## Addendum 02

Date: November 16, 2010

To: Wright Ryan Construction (Construction Manager)  
From: Ben Walter, CWS Architects  
Regarding: **Oak Street Apartments** – Portland, Maine  
Subject: **Addendum 02**

SK-2

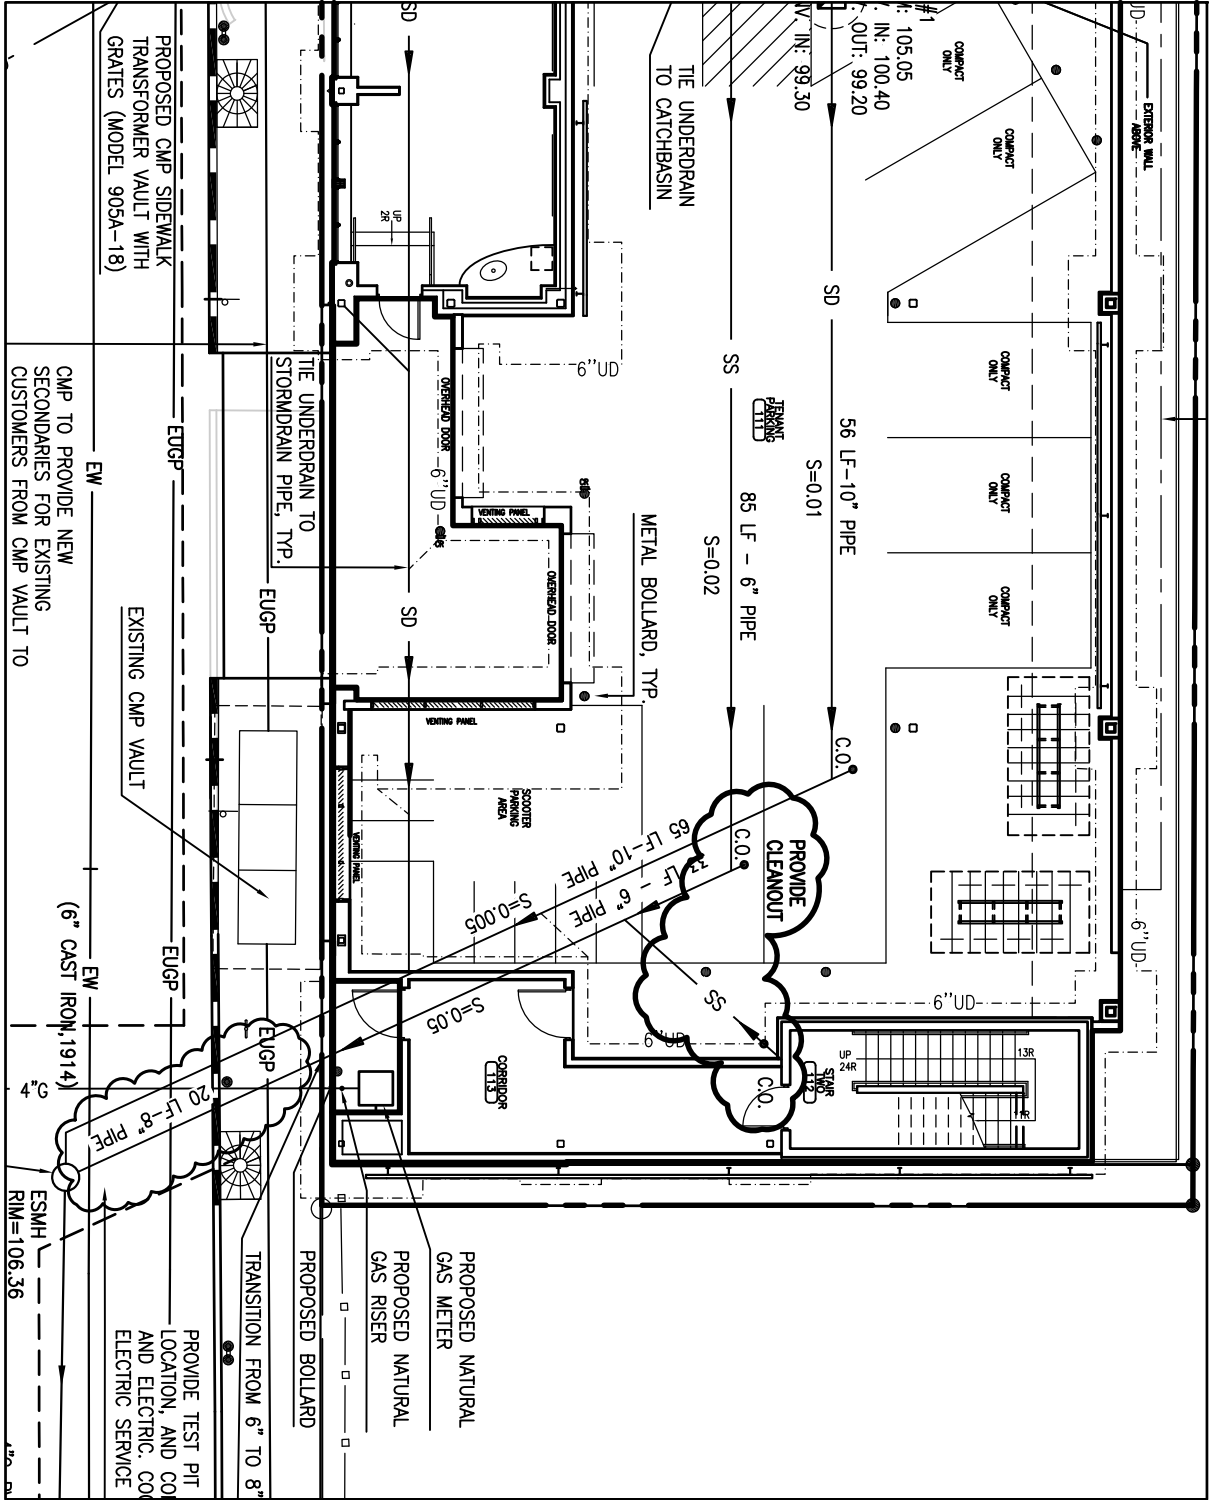
- 22. Tie elevator pit foundation drainage system into CB#1 with solid 4” PVC pipe.

**SKA-2**

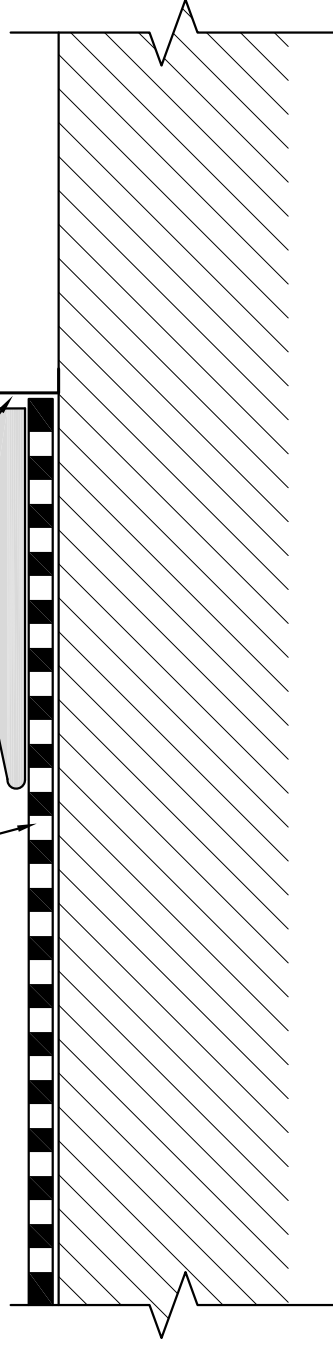
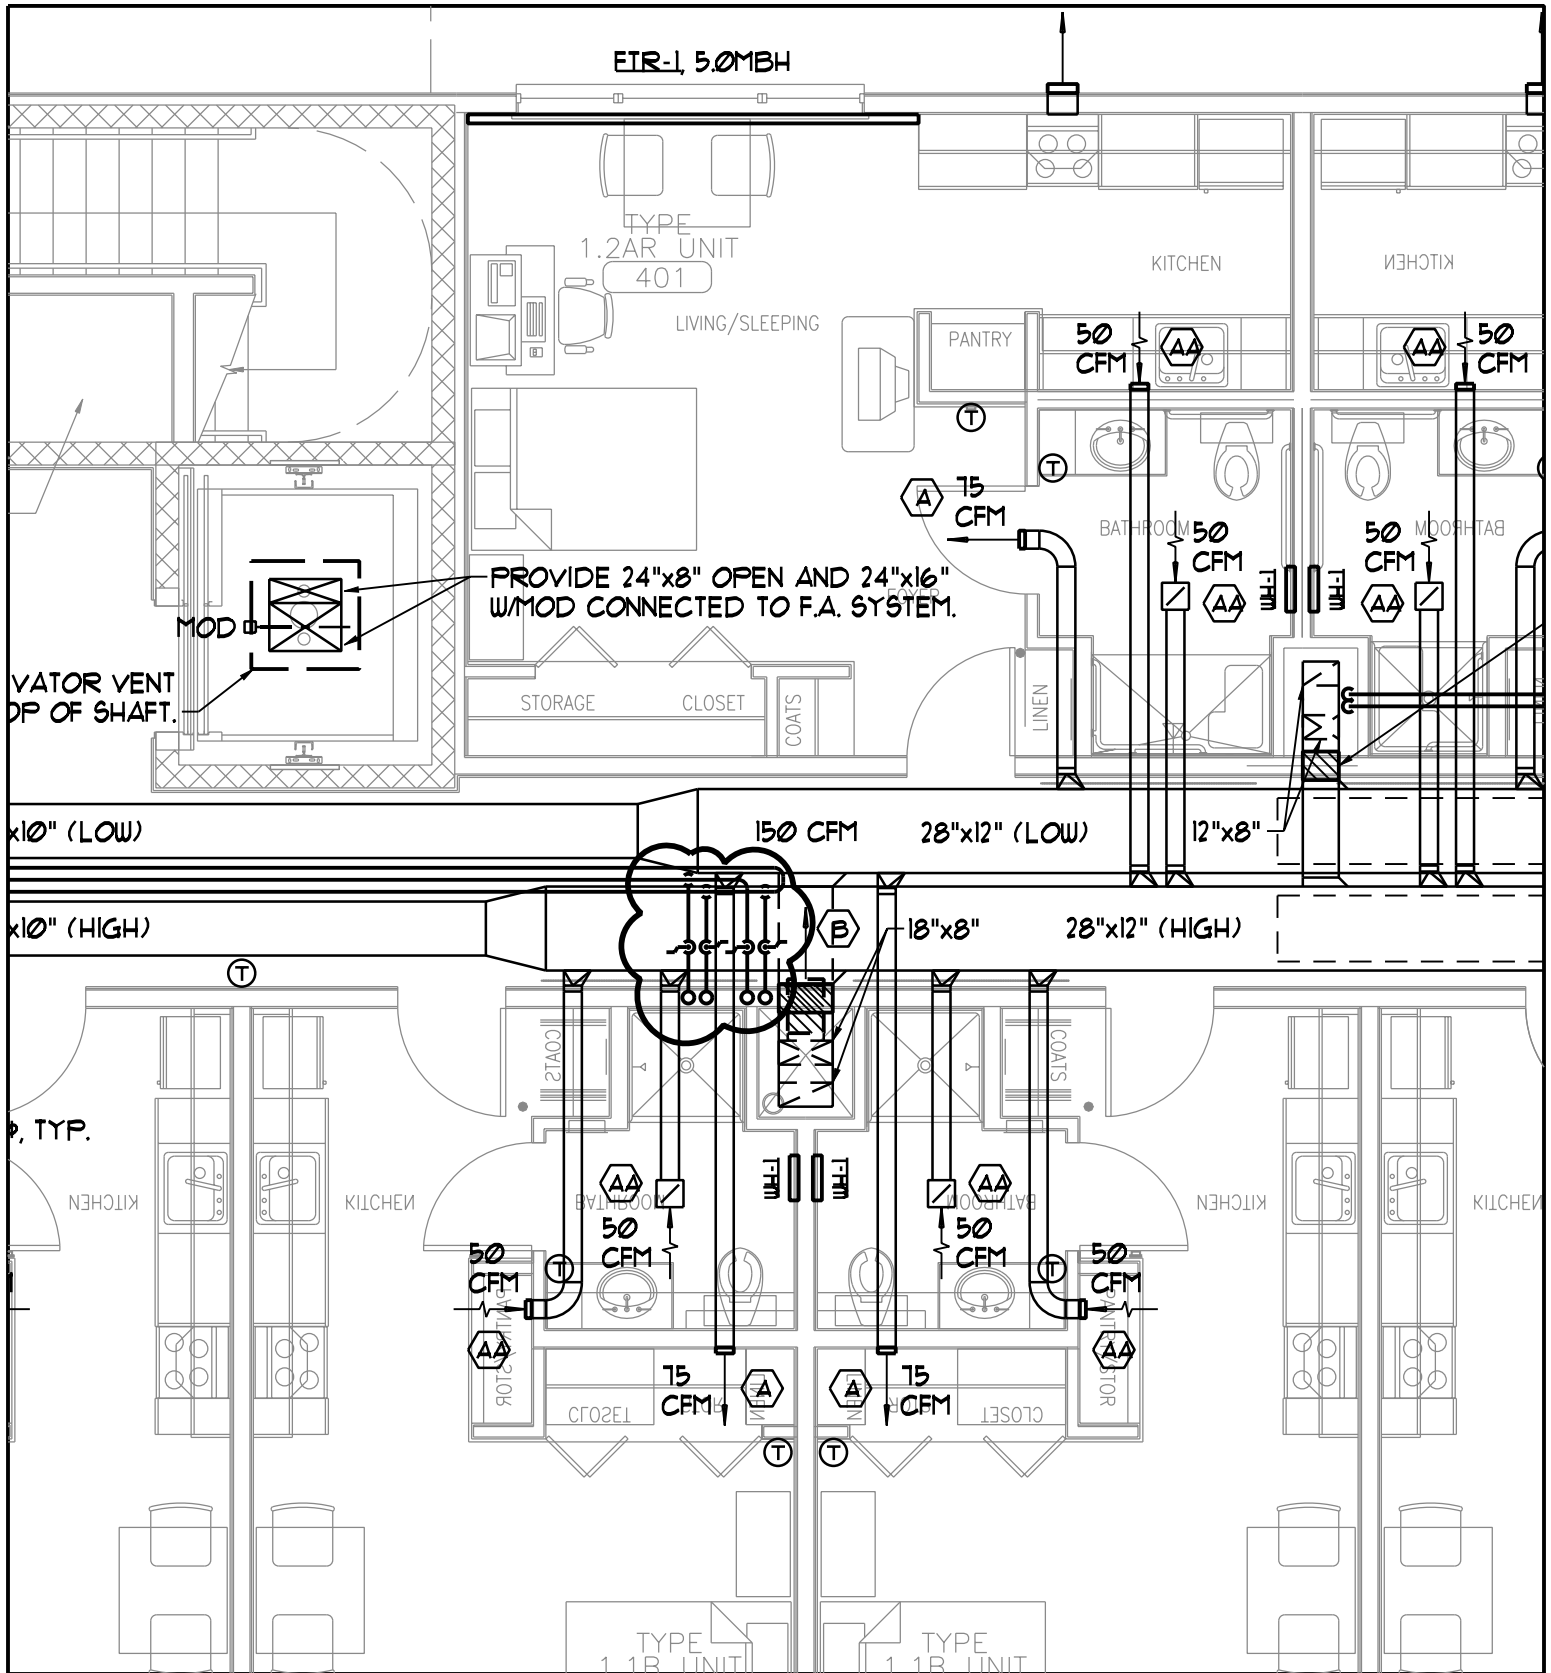
28. On Drawings A 1.8, change all detail reference of flooring transitions at roll in showers to reference Detail 5/A4.13. On Drawings A1.6, A1.7 and A1.9, provide flooring transitions to transfer showers per attached SKA-2 (attached).

SKM-1

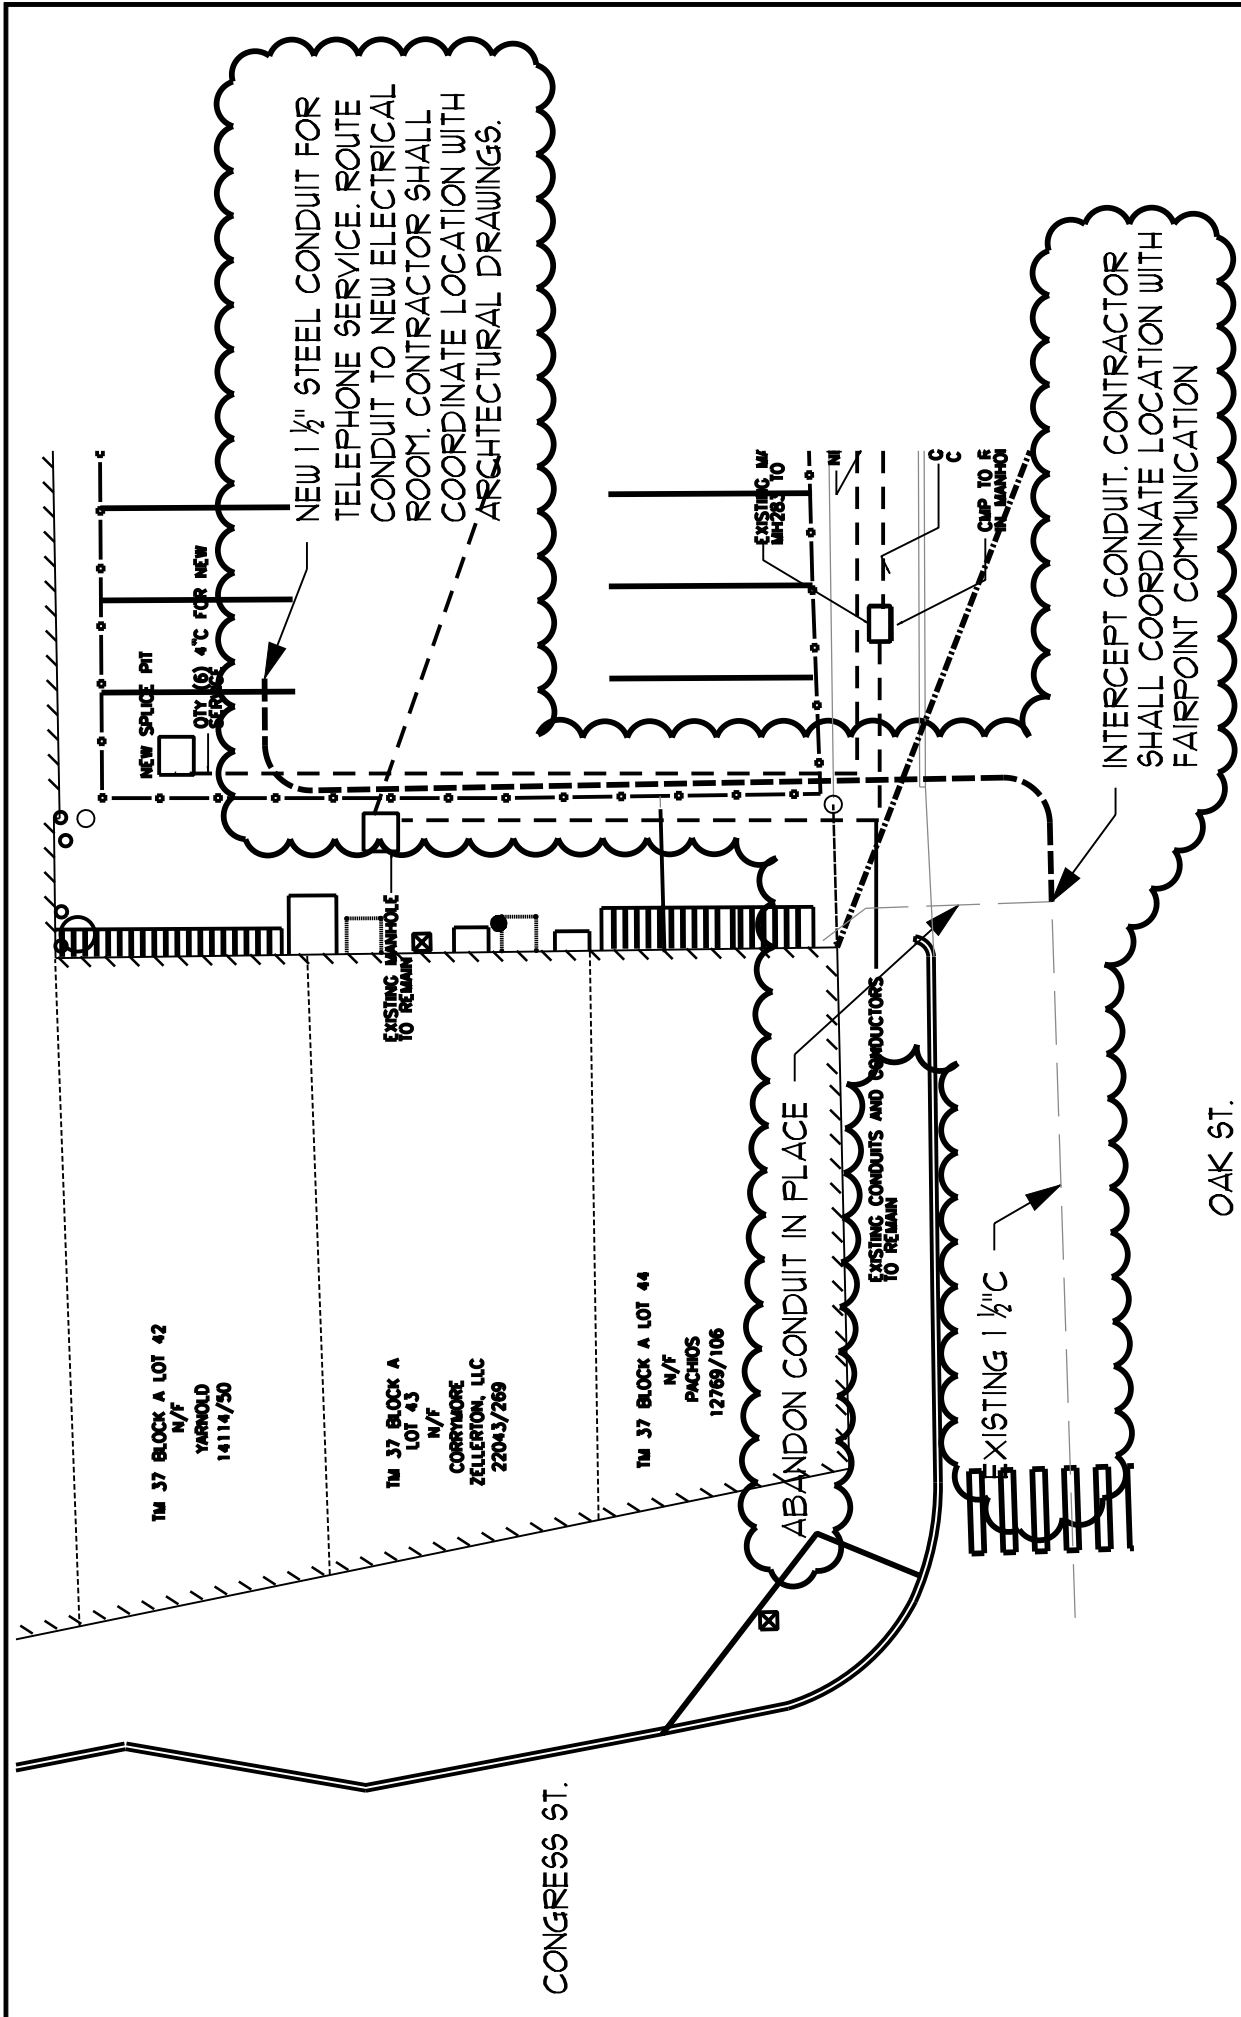
29. Attached is SKM-1 which was inadvertently omitted from ADDENDUM 01 and referenced in item number 21 as follows: “Drawing M1.4 - Add solar collector piping from 4th floor ceiling cavity up to collectors on roof as shown on SKM-1.”
30. DRAWINGS AND SPECIFICATIONS – Delete references to ERV-1 alternate to add dehumidification to Unit ventilation system, not allowed per MHD&C Manual.
